Office Action Summary	Application No. 10/590,284	Applicant(s) ABUMUSTAFA, ANWAR	
	Examiner AMENE S. BAYOU	Art Unit 3746

DETAILED ACTION

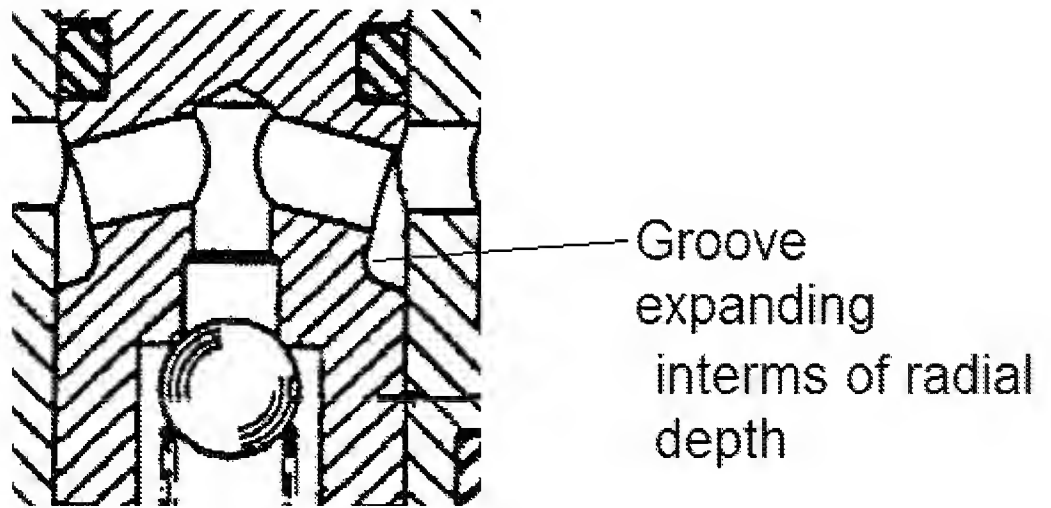
- Axial inflow orifice (18) extending cylindrically to a beginning of radial outflow orifices (26), in figure 1. Abumustafa's admitted prior art in view of Yarnall et al. however fails to disclose the following limitation which is taught by Bartussek et al.
- Circumferential outflow groove (marked below for clarity). expanding in terms of a radial depth on an outer circumference of the piston towards the control edge, in figure 5 .

making the circumferential outflow groove to expand in terms of radial depth upto a control edge in order to have smooth flow transition between the discharge orifice and an outlet connection (the curved surface helps smooth flow).

- The outflow groove expands in a conical form on a piston side and, as the result of a radially, inwardly directed arc, subsequently reaches a greatest depth in a region of the control edge (clearly shown in the marked drawing above).

- Diameters of the radial outflow orifices extend from the axial, cylindrical inflow orifice into the radially, inwardly directed arc in the control edge region (see figure above).
